EPC STORMWATER REVIEW COMMENTS ARE  
SHOWN IN ORANGE BOXES WITH BLACK TEXT

**Preliminary and Final Drainage Report  
Peaceful Ridge at Fountain Valley Subdivision  
El Paso County, Colorado**

PCD File No.  
EGP-213

Peaceful Ridge Sub Schematic layout of storm system with designations.

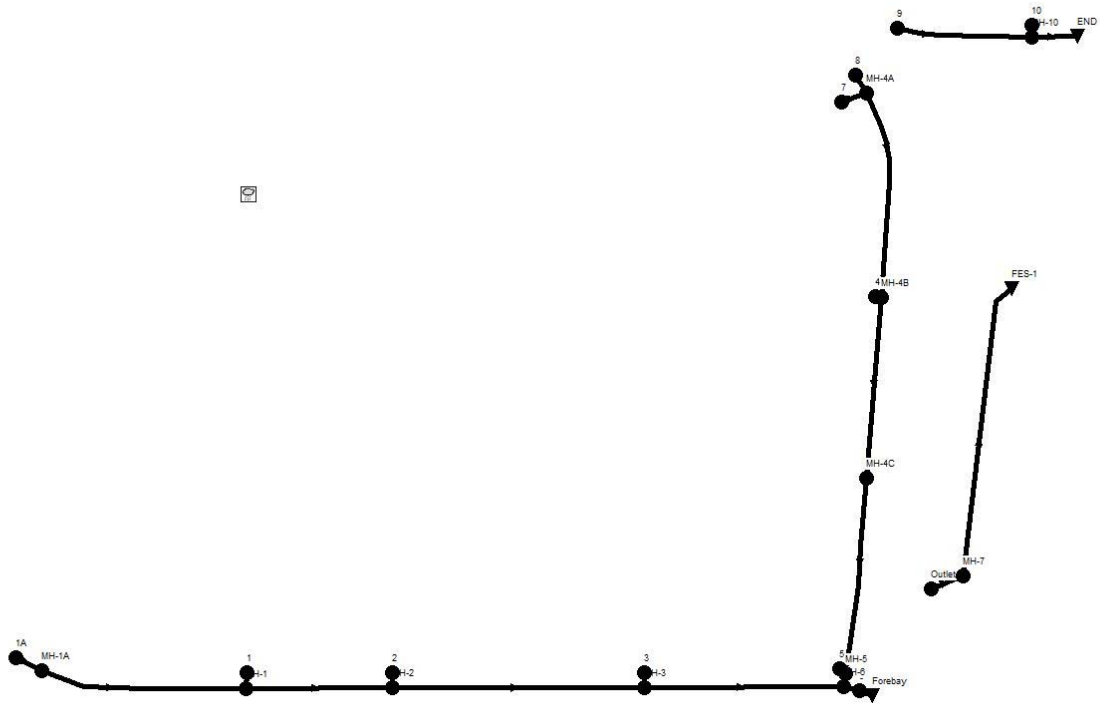
Please remove any storm system information from report and just show tributary areas and how they drain to TSBs. Hydraulic calculation should be for swales conveying runoff to TSBs.

Project: **04092 Peaceful Ridge at Fountain Valley Subdivision**  
 Channel ID: **Existing swale along southern boundary line**

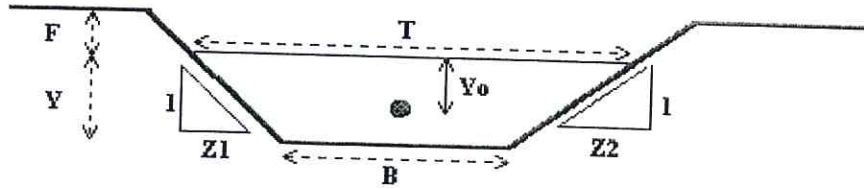
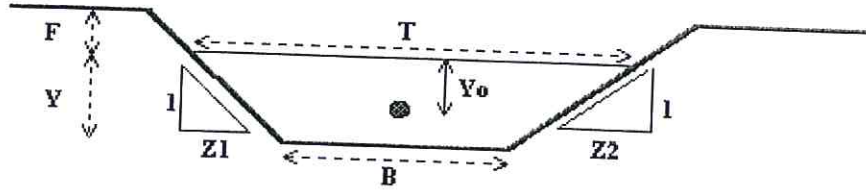
provide calculations for 2-yr storm. Maximum flow velocity of the channel shall not exceed 2 feet per second at the 2-year peak flow rate (DCM Vol. 2)

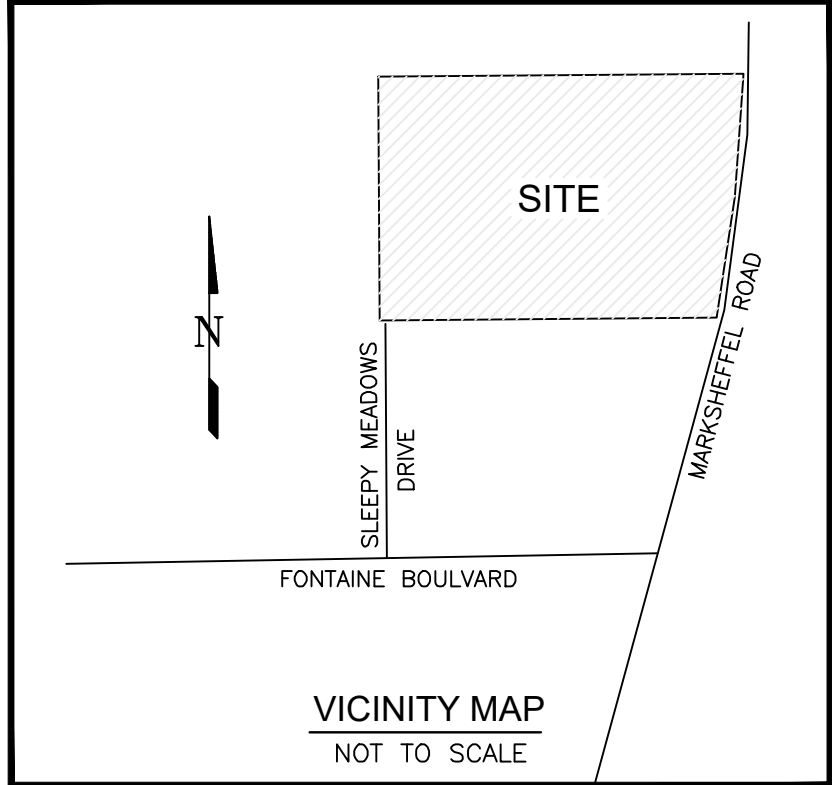
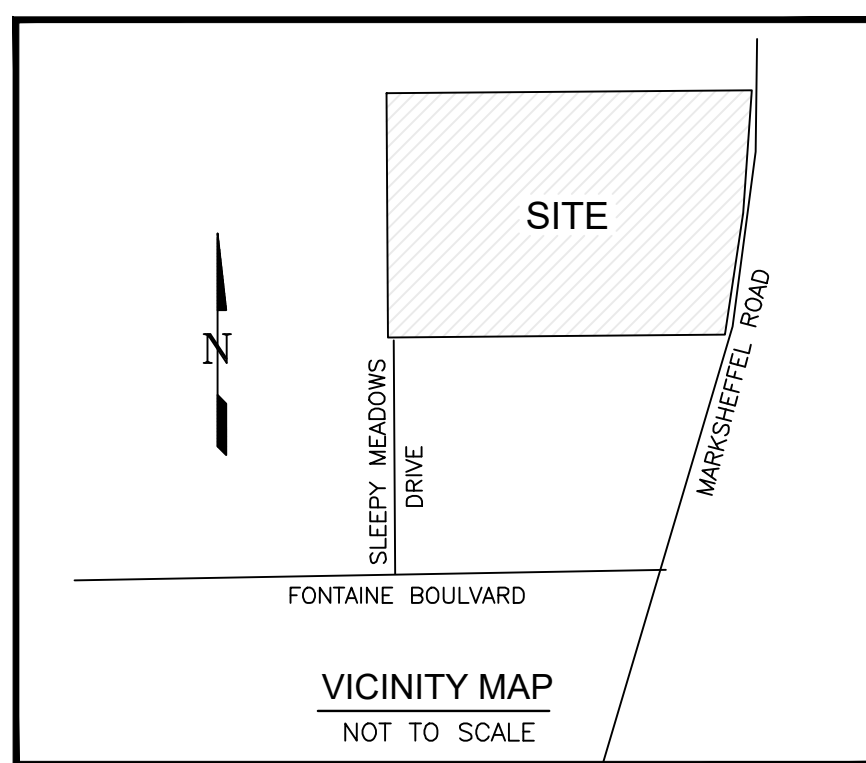
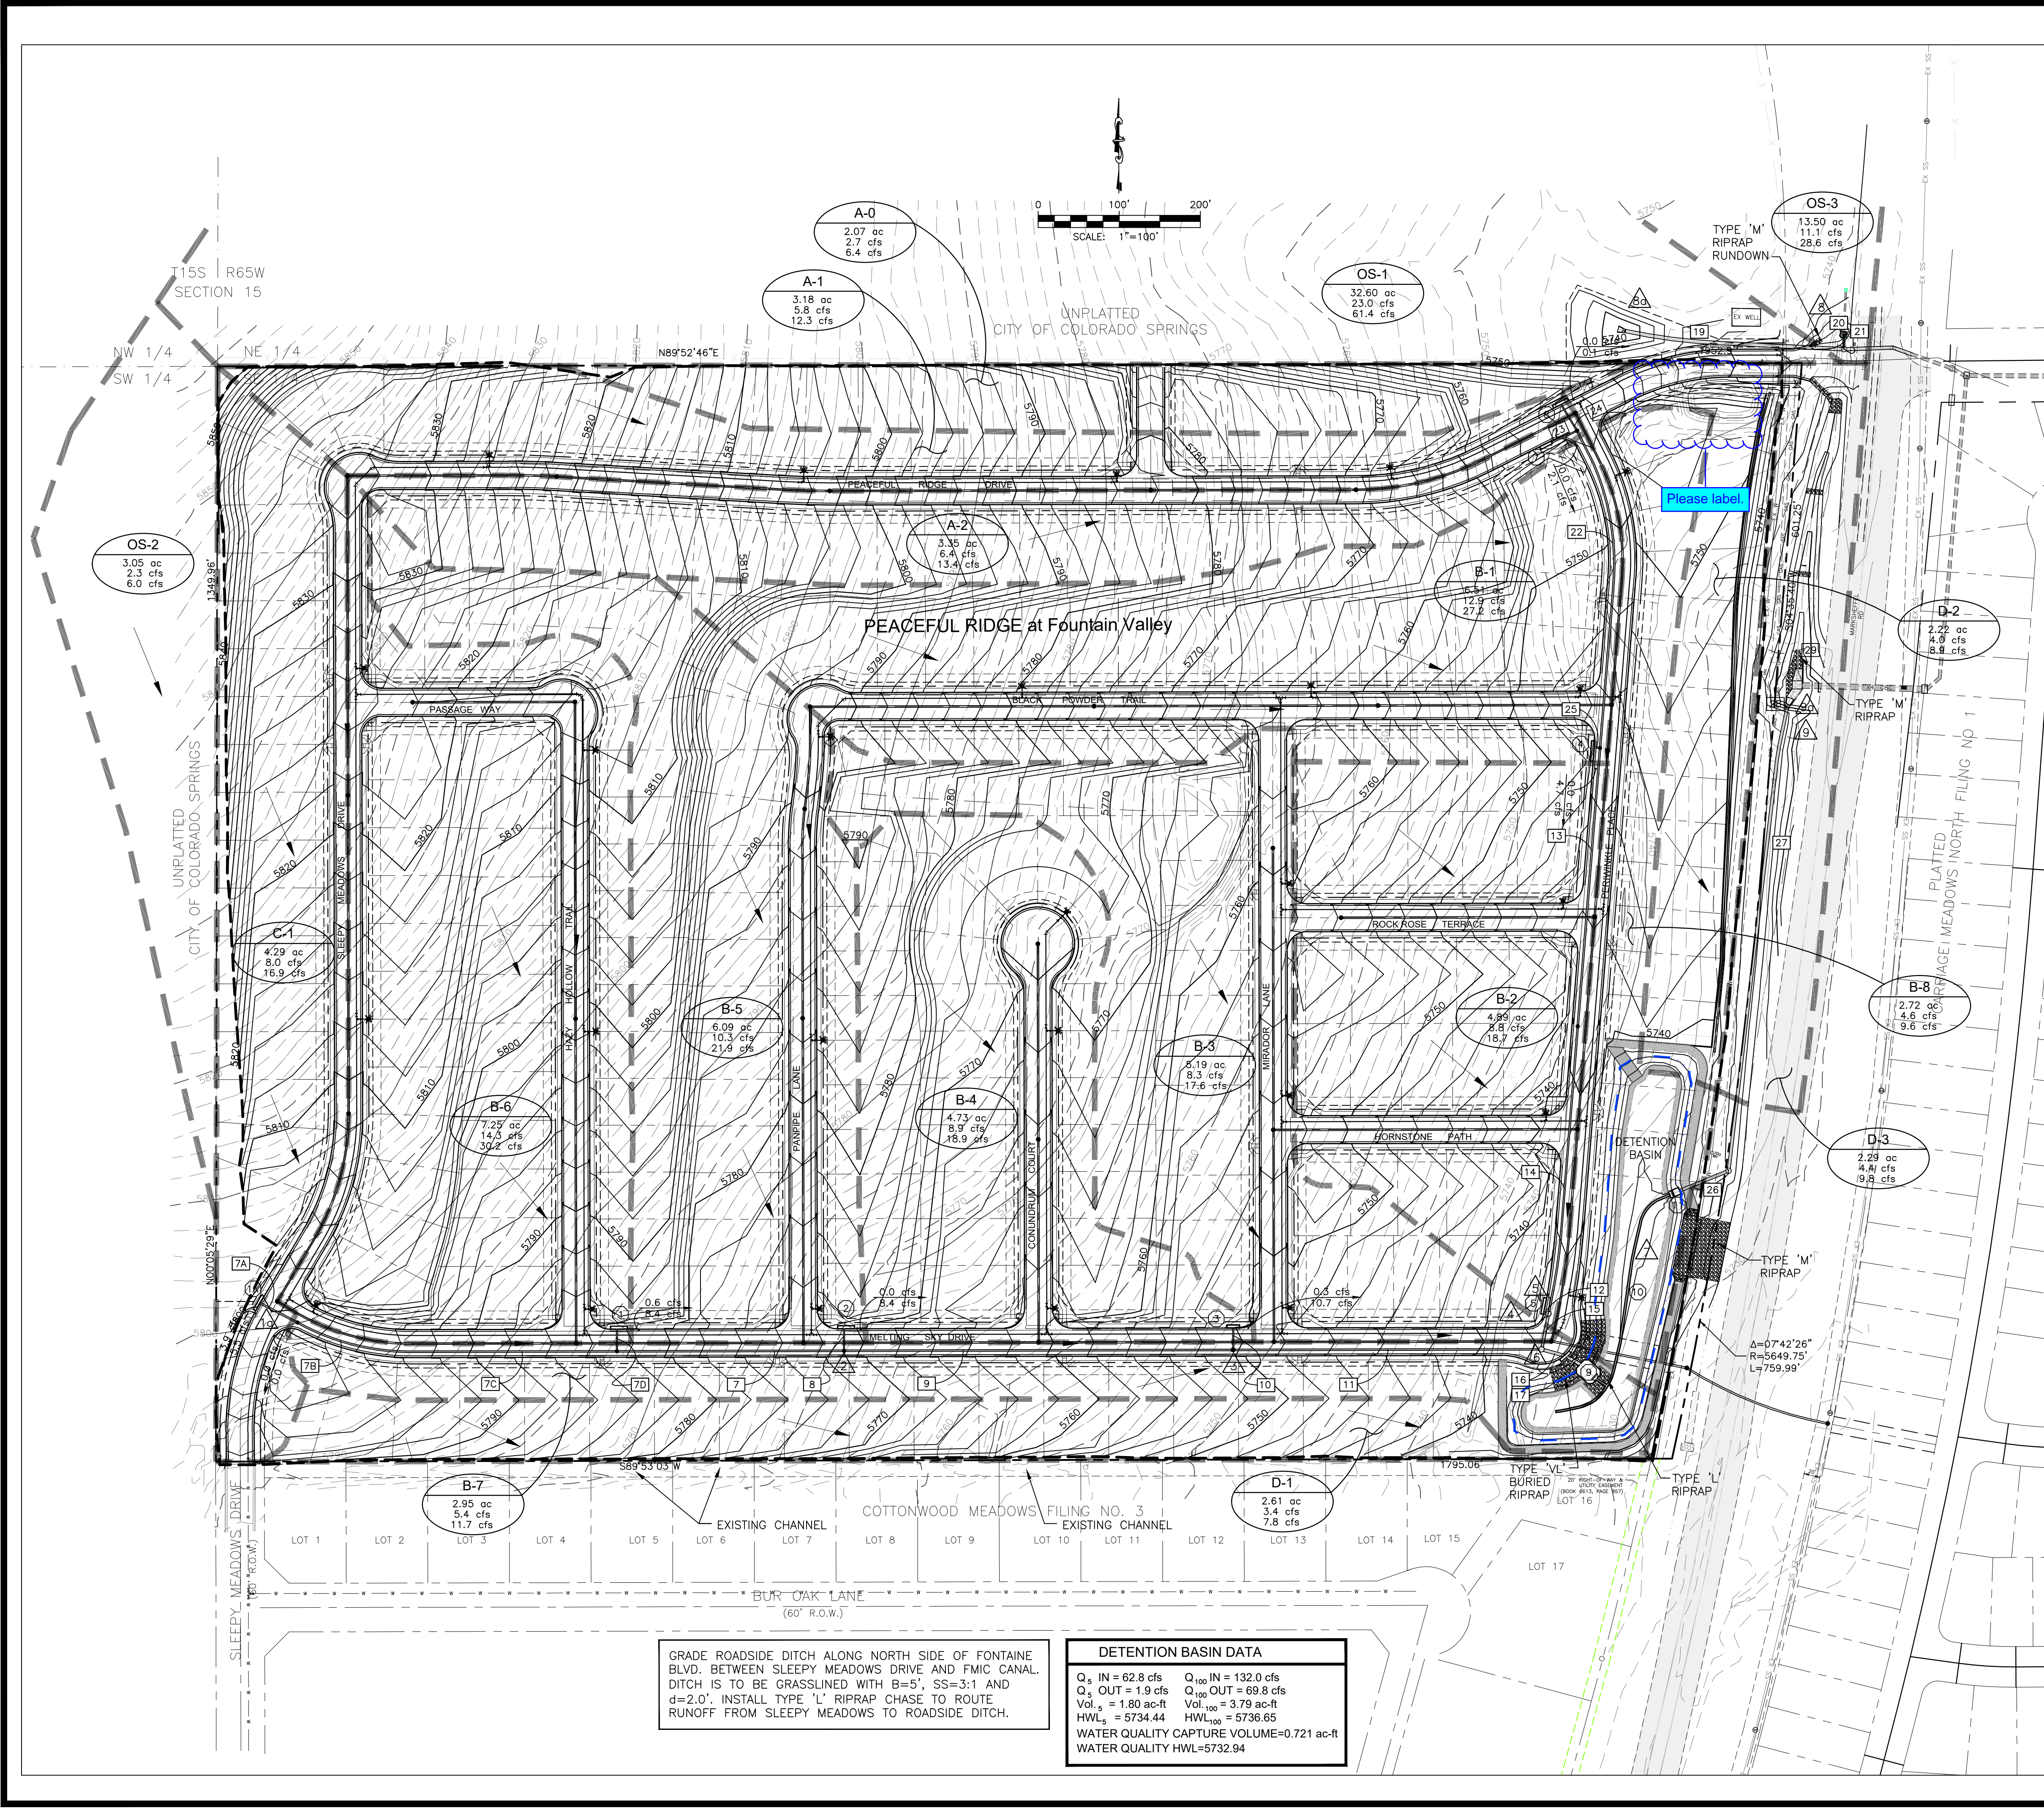
Please remove final build out drainage maps and replace with work that will be done with early grading plan: rough cutting roads and overlot grading.
